Title: Interstate 5 Riverfront Reconnection ("Bridging I-5") Project (T15998100)

Exhibit B: Comments Responses

I-5 Riverfront Reconnection Project

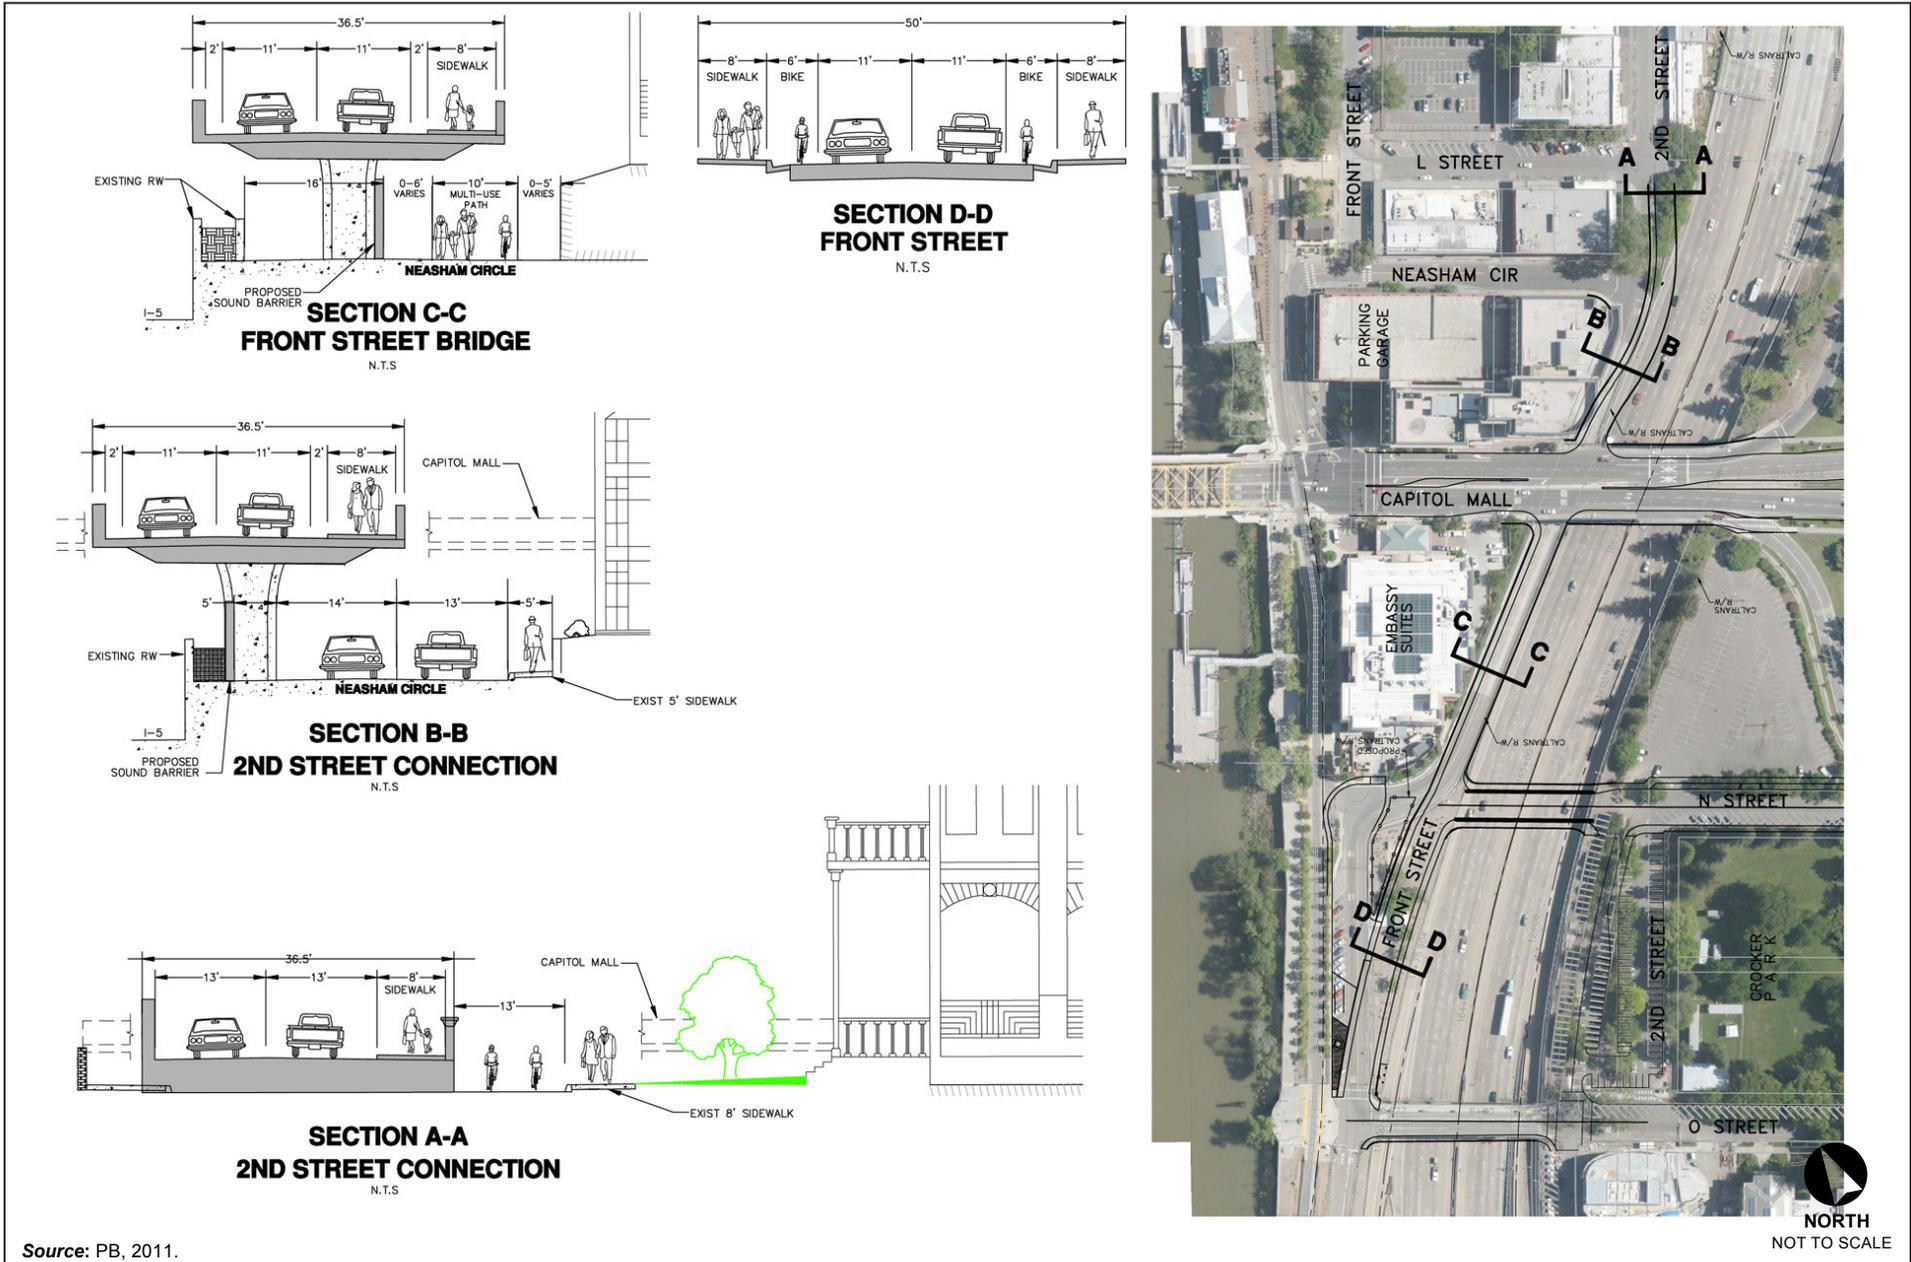
Section D-D of Figure 4 shows bike lanes between N Street and O Street but as depicted the gutter pans will take more than half of the bike lanes. We request that gutter pans on the viaduct be reduced to the minimum possible to provide an adequate bike lane.

FIGURE 15
Number of Lanes, Parking, and Daily Traffic Volumes -
Existing Conditions with Project

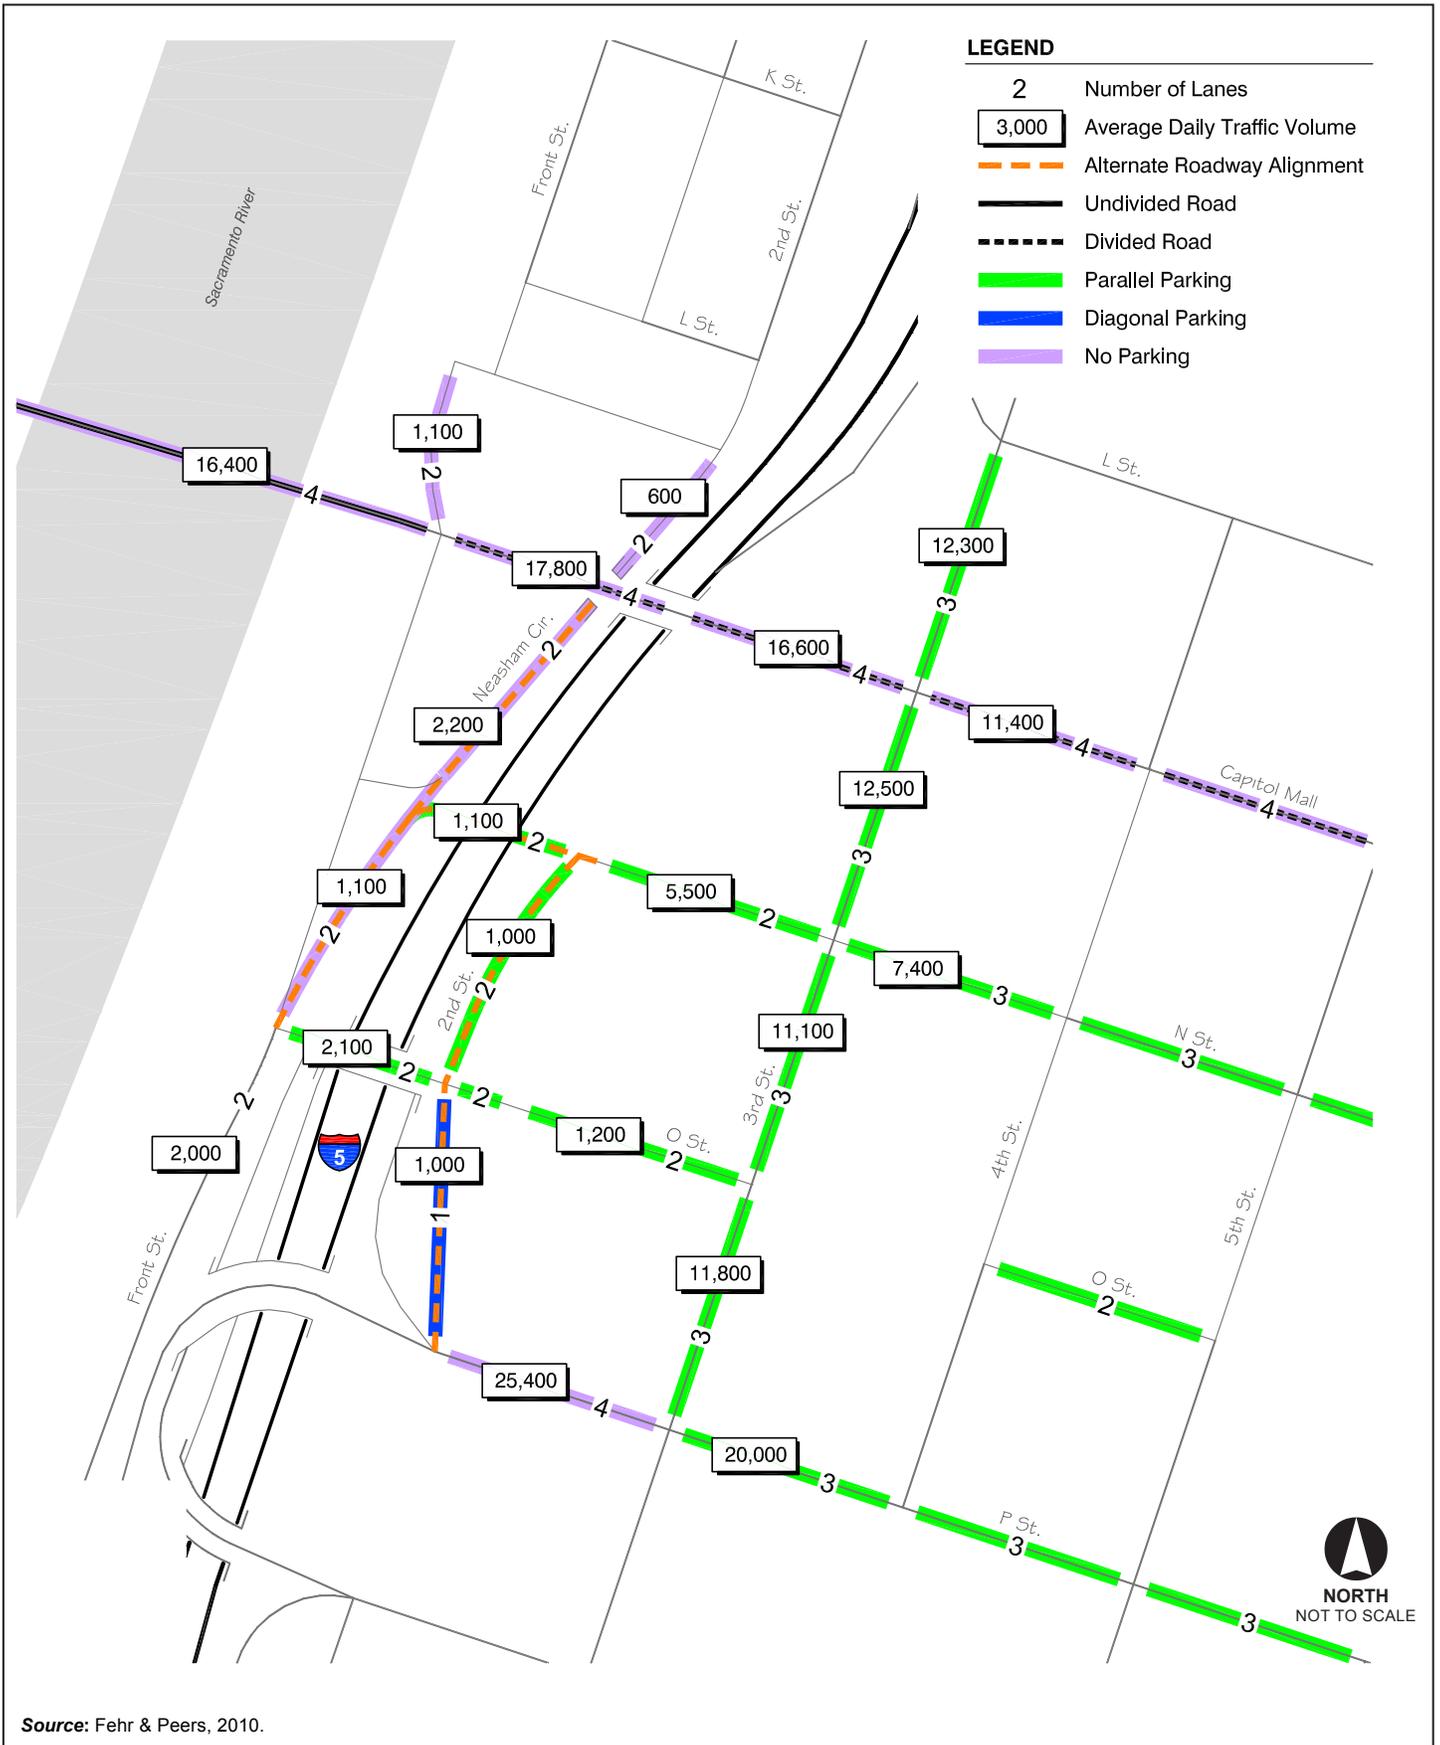
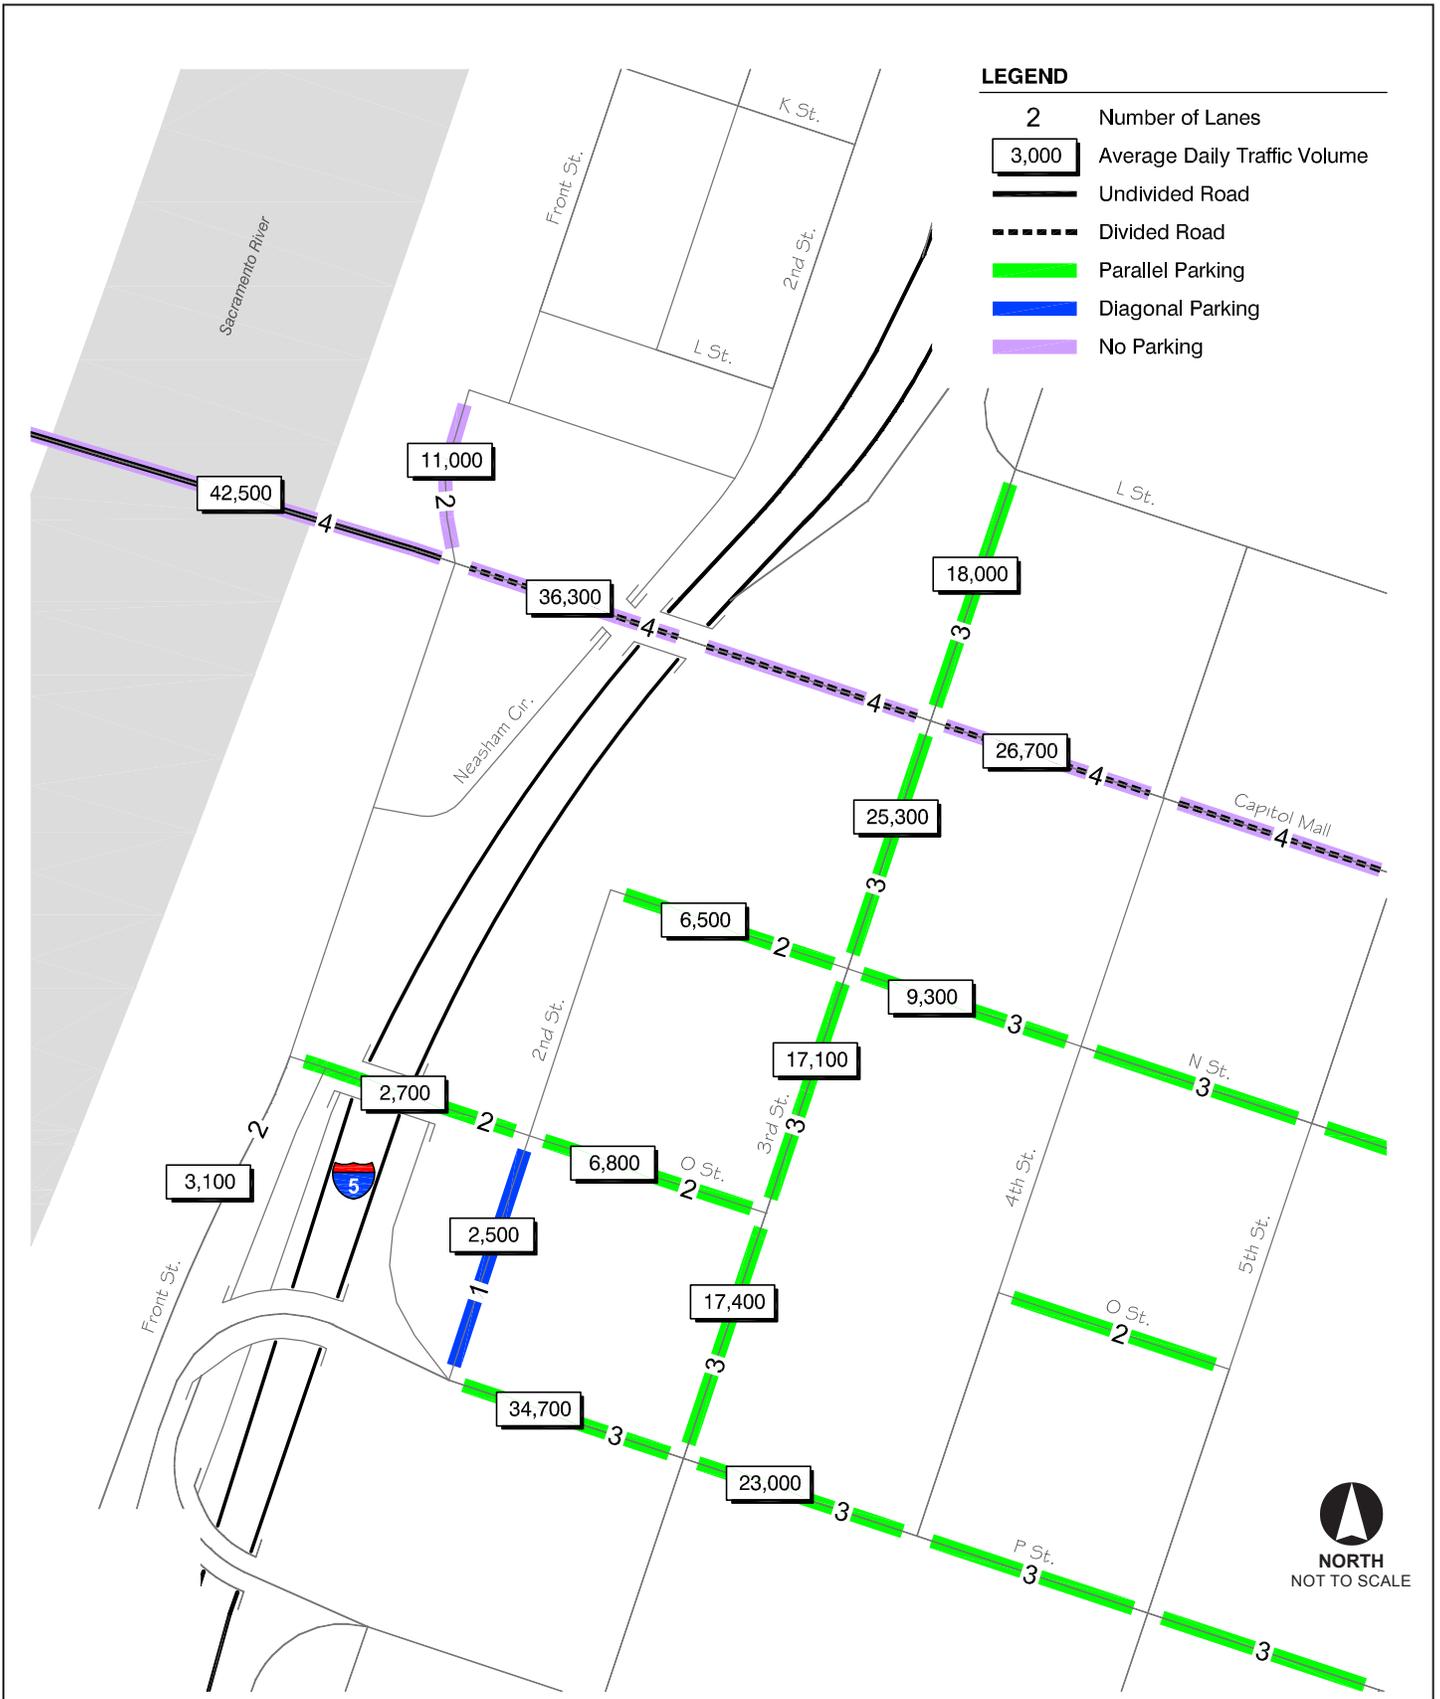
In studying the vehicular traffic count data provided in the document, we are puzzled by wide variations between the numbers cited in Figure 15 (Existing Conditions With Project) and those found in Figure 17 (Year 2035 No Project). In particular, at the current Front Street (south) entrance from Capitol Mall into Old Sacramento, the 1,100 trips cited for “existing conditions” if the project is implemented, somehow balloons to 11,000 in the year 2035 at this same entrance, if the project is *not* implemented.

In comparing the graphics in the Traffic Report, located in Appendix B of the Initial Study, Figure 5 (Existing Conditions) shows 1,700 Average Daily Traffic (ADT) on Front Street compared to 1,100 with the project (Figure 13 -Alternative 3, Existing Conditions with Project), which is a reduction in traffic due to the redistribution of traffic following implementation of the Project.

When Figure 23 (Year 2035, No Project) is compared to Figure 5 (Existing Conditions), the traffic on Front Street in Old Sacramento is projected to rise from 1,700 ADT to 11,000 ADT. This is based on assumed development in the area projected to occur by year 2035. The effect of the project can be seen by comparing Figure 23 (Year 2035, No Project) to Figure 29 (Alternative 3, Year 2035, With Project). With the additional I-5 crossing including in the Project (the proposed N Street Bridge), the project would relieve some of the traffic in the vicinity of Capitol Mall. In addition, the forecasted traffic on Front Street drops from 11,000 ADT without the project to 3,000 with the project.
